AMENDMENT

Trignition Media LLC, licensee of WRYM, FI 26314, New Britain, Connecticut, hereby amends its pending application BP-20220630AAD with the attached material.

ENGINEERING REPORT COVERING
OPPOSITION TO THIRD INFORMAL OBJECTION
TRIGNITION MEDIA, LLC
FOR WRYM 840 KILOHERTZ
NEW BRITAIN, CONNECTICUT

OCTOBER 2022

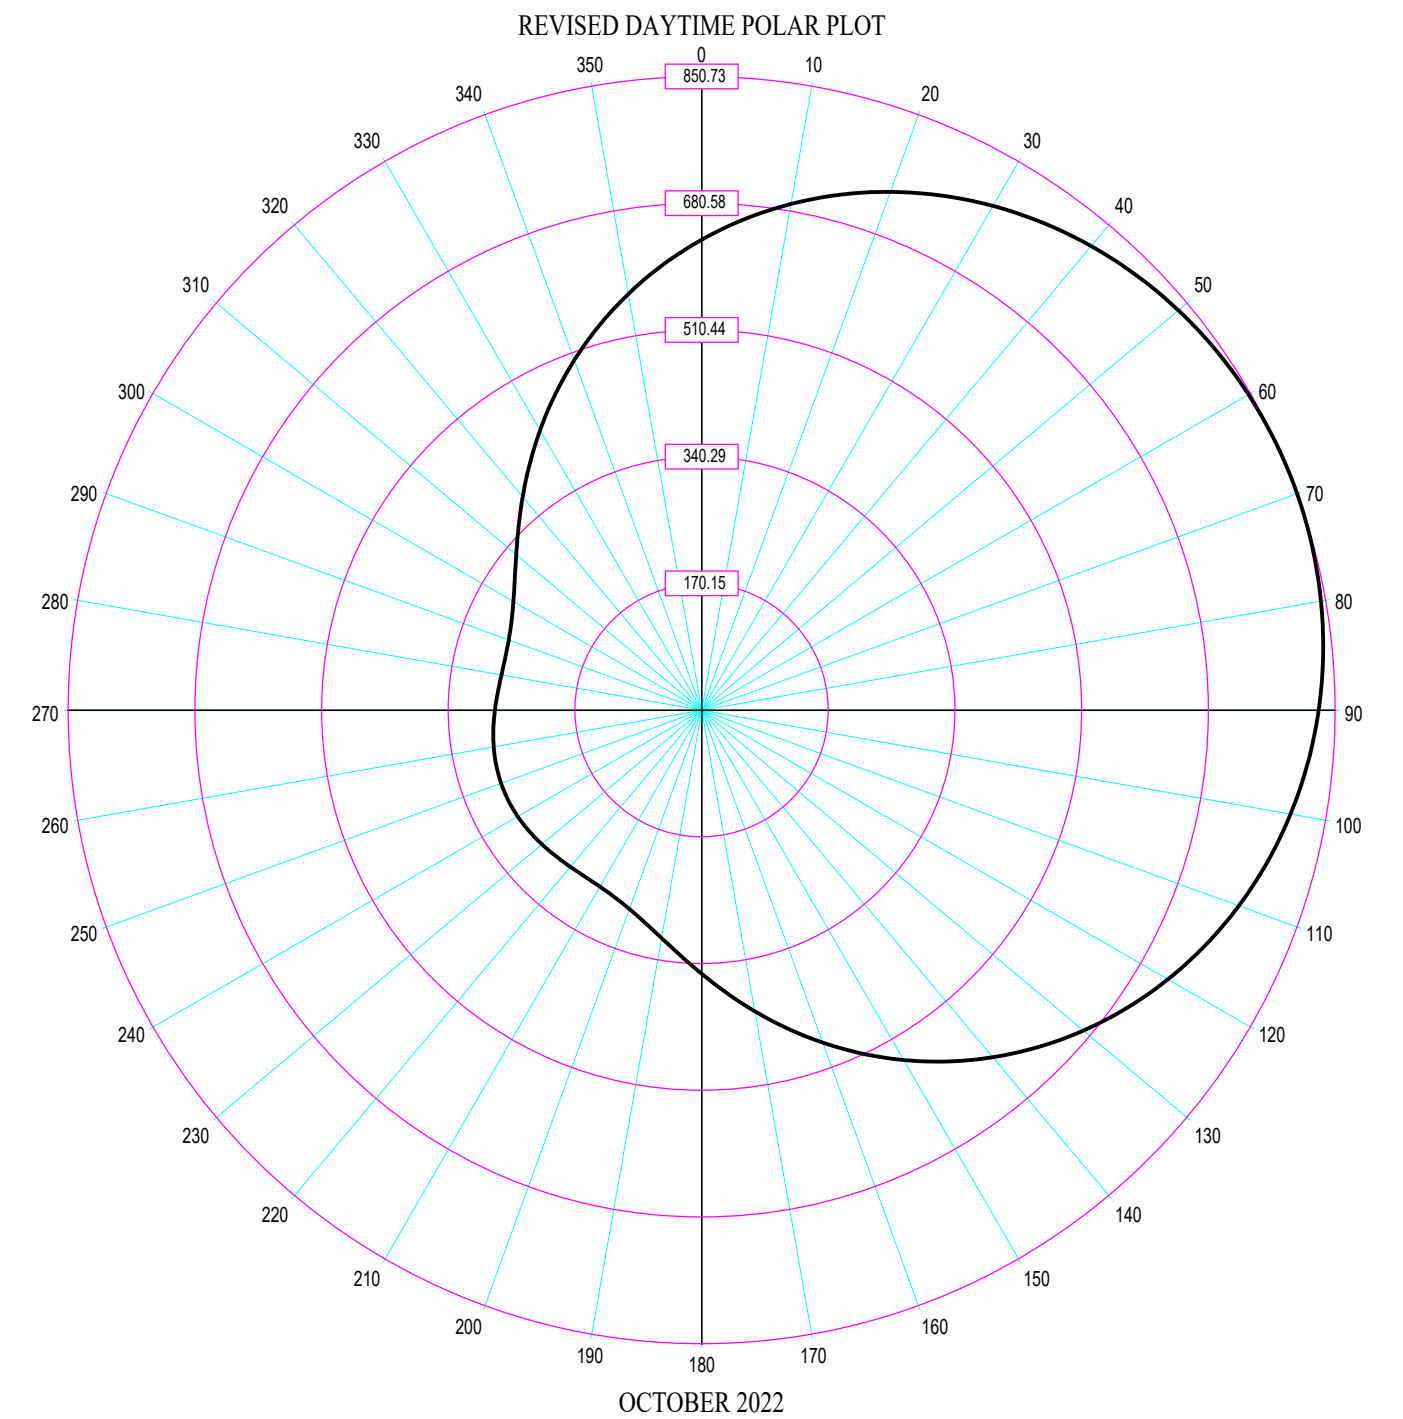
Trignition believes their first and second oppositions resolved the overlap issue raised in the Carter objection. However, Carter's third objection states the second CRN opposition still produces a very small overlap area with WCRN. Trignition has reviewed Carter's third objection and believes the small overlap area in question is produced by small differences in contour distances that are software related.

Rather than debate the software issue and to expeditiously settle the overlap question, Trignition will amend its application to reduce daytime power to 3.2 kilowatts. A revised polar plot with horizontal radiation tabulations is included with this report along with an amended Form 301. No other changes are proposed. The amendment will eliminate the overlap claimed by Carter. Therefore, the Trignition application should be granted.
